**Seattle
Design
Commission**

**MINUTES OF THE MEETING
19 September 2002**

Projects Reviewed
Lincoln Reservoir
Yesler Community
Blue Ring Strategy
Bergen Place Park
Transportation Discussion

Yesler Community Center site analysis

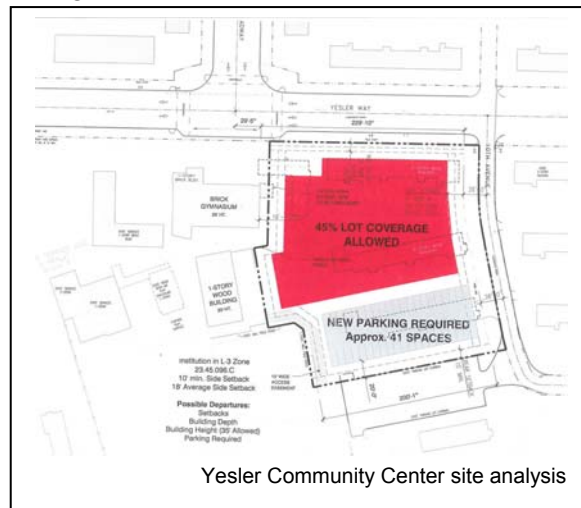
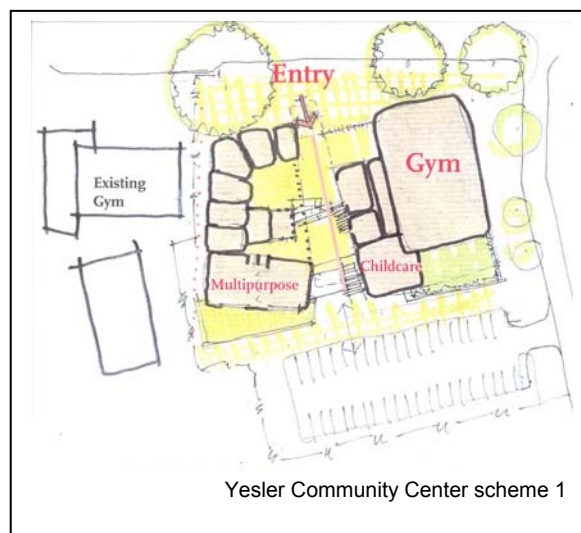
- Recognizes that the site has shrunk, but feels that it is still necessary to know what SHA plans for the open space because in option 2, the site is closed off to the adjacent SHA property, while in option 1, it is more open to that property.

- Feels that there are broader planning issues that must be addressed. A directive of open space strategy is to enhance view corridors and create connections to open space. Suggests that a massive structure in this zone would create conflicting urban design issues. Supports the streetwall scheme and encourages proponents to emphasize the edge and set up a direction for future development.

- Would like drawings to show the property at the foot of Broadway as they have shown Yesler, even though it is not part of this site. Like Broadway, the uses along Yesler are very important to the presentation because they are the components that make it a community center.

- Feels that the more this space opens up to its neighbors, the more the neighbors will open up to it. Believes that the potential 8' wall is intimidating and that the point at the southwest corner is too sharp. Would like proponents to ease up on that corner and possibly use the handicap ramp as part of the circulation system. Suggest that they think of the ramp as part of the stepping down of that slope rather than as being at the base of an 8' wall.

Yesler Community Center scheme 1

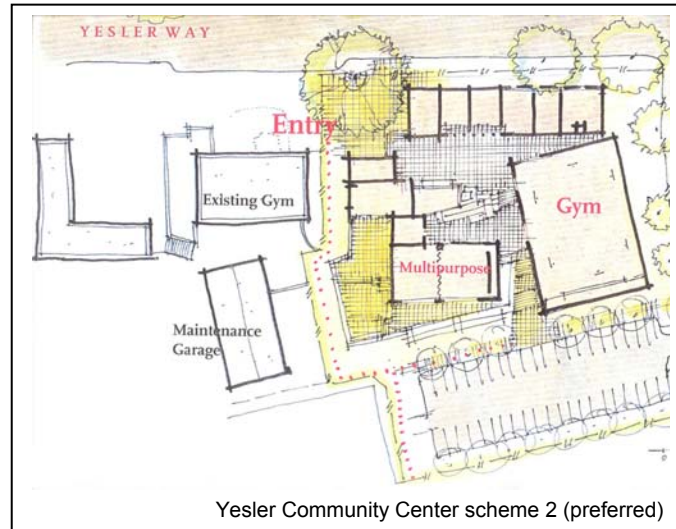
- **feels that the proposed parking scheme is suburban and needs to be redesigned for an urban setting by, for example, having fewer spaces, excavating for underground parking, creating a multiple-use parking lot, or allowing parking to be appropriated for other uses as the neighborhood develops;**

- Believes that the parking should be brought closer to the building because the space in between is not useful. This provides more space for stormwater treatment and feels that losing open space for water treatment is a worthwhile tradeoff.

- Believes that proponents are building a neighborhood service center geared toward a neighborhood soon will not exist, the neighborhood will change. Feels that it is a suburban plan for a place that is becoming more urban. Would like these buildings to establish a design direction and be more urban because what we see now in the neighborhood will not exist in the future. Believes that if there is an 8' differential, perhaps the parking should be underground rather than at grade.

- Would like proponents to make the west edge more open, create a smaller footprint for parking, and provide better experiential conditions relative to the SHA site.

Bergen Place Park alternative 1: Street life

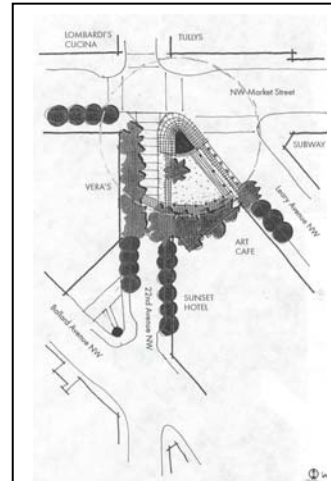
- **urges the team to look carefully at the edges of the site;**
- **suggests that the team come up with three more quick design variations when presenting at the public meeting this week;**

- **urges the team to define the space through its geometry and prominent corner;**
- **feels that 22nd should be maintained as a through street with parking on it; and**

Bergen Place Park alternative 2: Marvin Meet Bergen

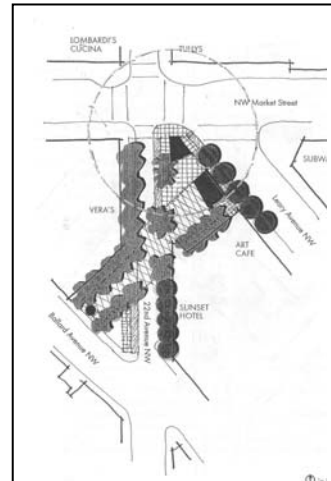
- Feels that a series of uses does not activate a space. Would like to see a return to a simpler notion of what spaces can be. Feels that attempting to link to Marvin Gardens squeezes the street and goes against making an interesting space on the corner. Would like to see a big, simple design rather than a fine-grained solution, such as an architectural frame or trees. Believes that in the future, two trees could link the spaces identifiably. Would also like to see the corner well defined.

- Believes that a connection between the parks is an interesting idea. Although much of the new traffic can move to the park to the north, people will move through these spaces naturally across 22nd. Would like to see that movement reinforced in a way that still defines Bergen.
